**Addendum No.1 Bid No.050421-Select Demolition at Eastin Arcola and MSHS**

This Addendum is attached to and made a part of the above-entitled specifications for Madera Unified School District for **Bid No.050421-Select Demolition at Eastin Arcola and MSHS**, with a due date of May 18, ~~20~~, 2021 @ 10:01 am

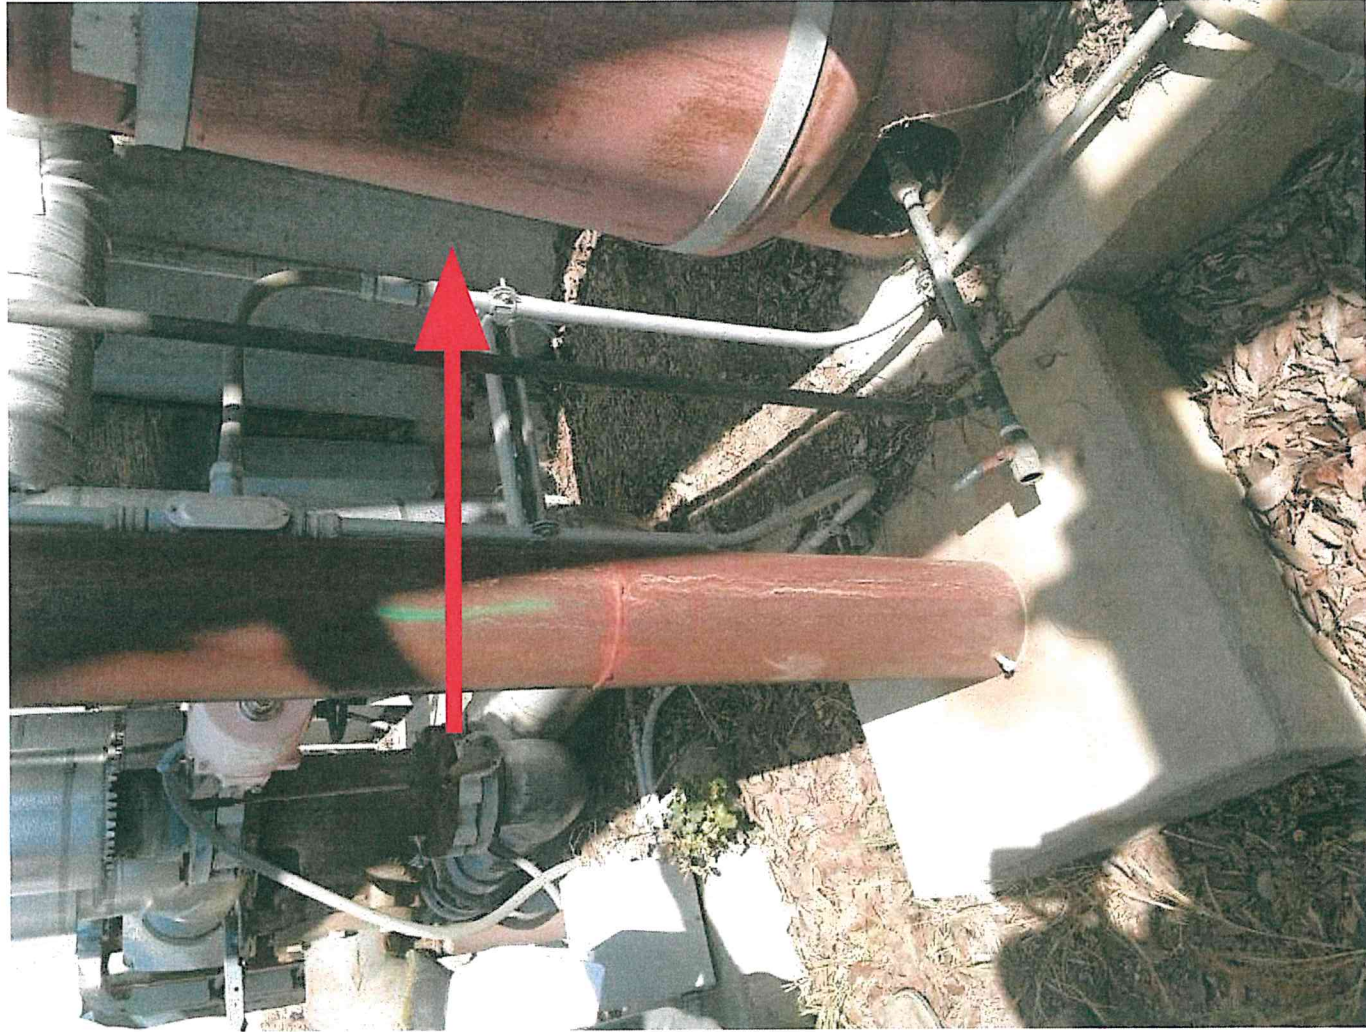
1. Leave all cement pads? **Please see the scope of work sections "D" and "E".**
2. Remove the heat exchanger? **Yes**
3. Remove the makeup water tank? **Yes**
4. Is the expansion tank going to be kept? **Yes, only the red tank. See the attached picture.**
5. Cut a base (grade) for the footings under the polls.
6. Does the District want to keep the piping along the wall? **Yes**
7. Are we removing the electrical panel on the wall and is the electrical wire live? **Yes, remove the electrical panel on the wall and remove the wires from the conduit.**

Bid No. 050421  
Addendum 1 - Eastin Arcola

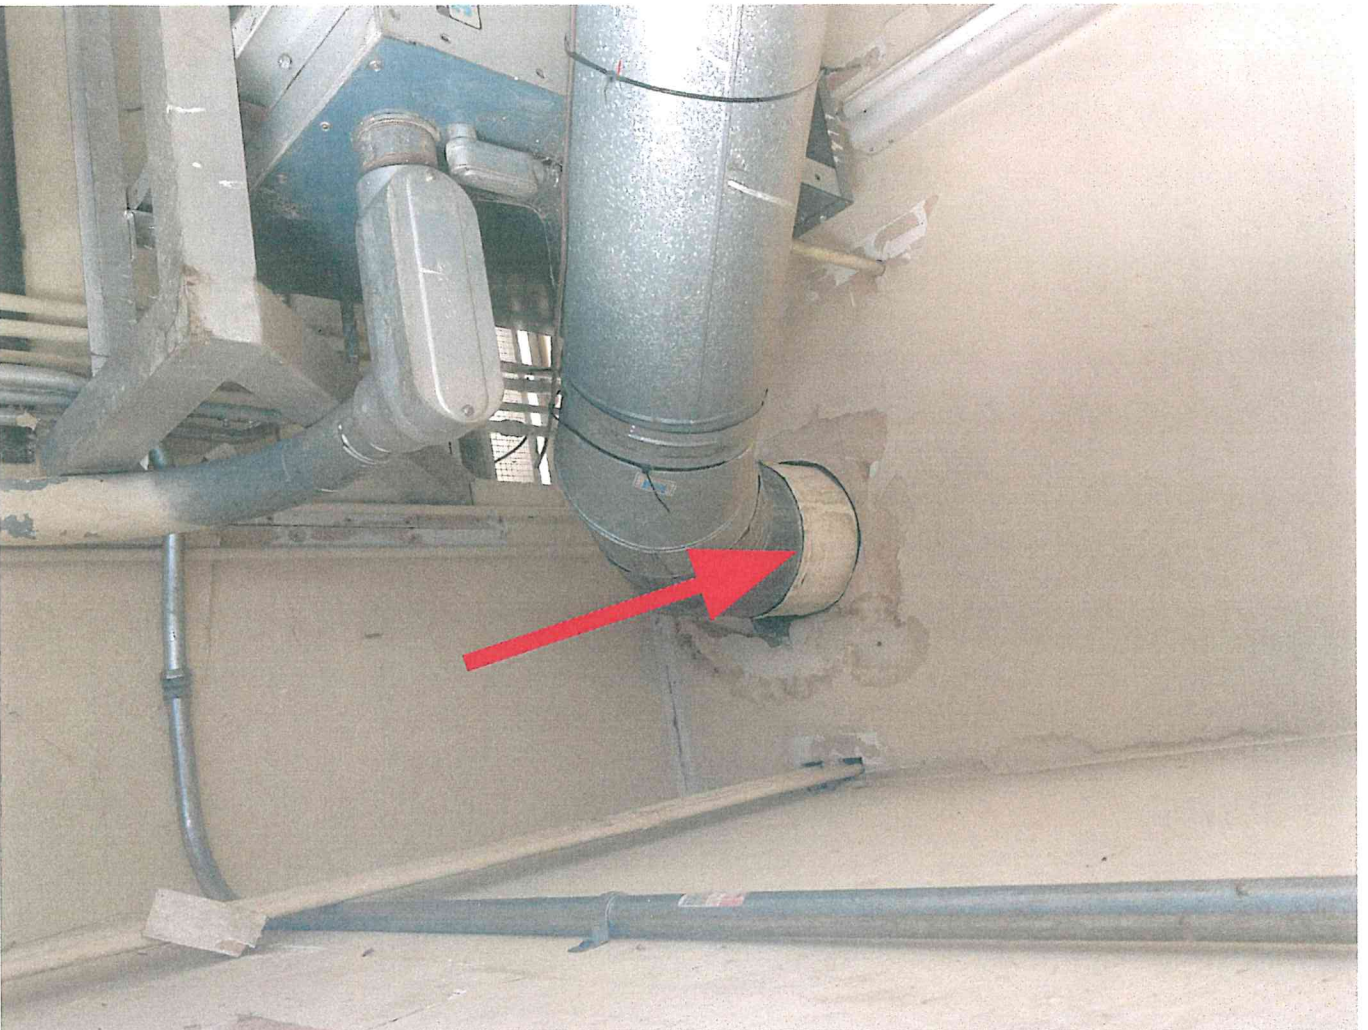
1. The contractor is to remove and discard all materials.
2. Contractor is to cap off – See attached picture.
3. Vent pipe - open for air handler? **Yes**
